Project 717

MFN 03-100
September 18, 2003

Subject: Response to Request for Additional Information (RAI) numbers (25, 306, and 319) for ESBWR Pre-application Review.

Response to NRC RAI numbers (25, 306, and 319)

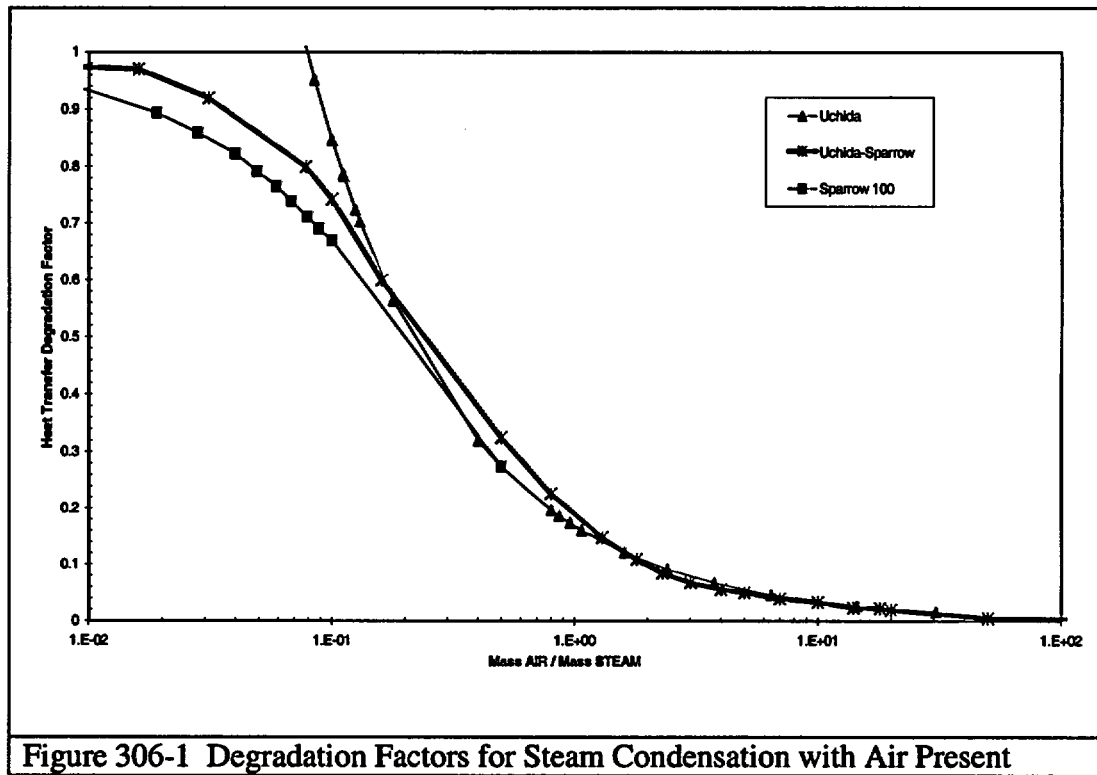
- Q306.2. How was the Sparrow-Uchida degradation factor obtained? Does the correction factor include any bias based on the Sparrow or Uchida data? Is it a "best-estimate" correction? What is the uncertainty in this correction factor and is it considered in the calculations?

- R306.2. The precise origin of the tabulated values that are referred to as the Sparrow-Uchida degradation factors is not known. There is reason to believe (as will be demonstrated) that these values were obtained by merging the separate results from Sparrow and Uchida. The tabulated values in the code are used to degrade the condensation heat transfer at the free surface between the mixture and vapor regions when a water level is predicted. The values are tabulated in the code as the ratio of air-to-steam density and are presented graphically in Figure 6.5-1 of NEDE-32176P, Rev. 2. That figure has been reproduced here as Figure 306-1 and additional curves have been added to allow the Sparrow-Uchida degradation curve to be compared with the curves attributed individually to Uchida and Sparrow.

The curve marked "Sparrow 100" in Figure 306-1 is obtained from Figure 10.4 from Collier's book. Collier's book is cited in NEDE-32176P, Rev. 2 as Reference [6.5-11]. Collier attributes this and 3 other curves shown in his Figure 10.4 to Minkowycz and Sparrow. The "Sparrow 100" curve that is shown here is the forced convection curve corresponding to a bulk mixture temperature of 100 C. It is clear that all four of the "Sparrow" curves are for relatively low mass fractions for air in steam over the range from 0.0 to 0.1. Here in Figure 306-1, the lowest point in the Sparrow curve has been extrapolated assuming the same slope as suggested by the previous two points.

Notice from Figure 306-1 that a transition from the Uchida to the Sparrow degradation functions is needed because the degradation factor due to Uchida alone increases unrealistically for the smaller air mass fractions. The suggested Uchida-Sparrow form does not have this undesirable behavior.
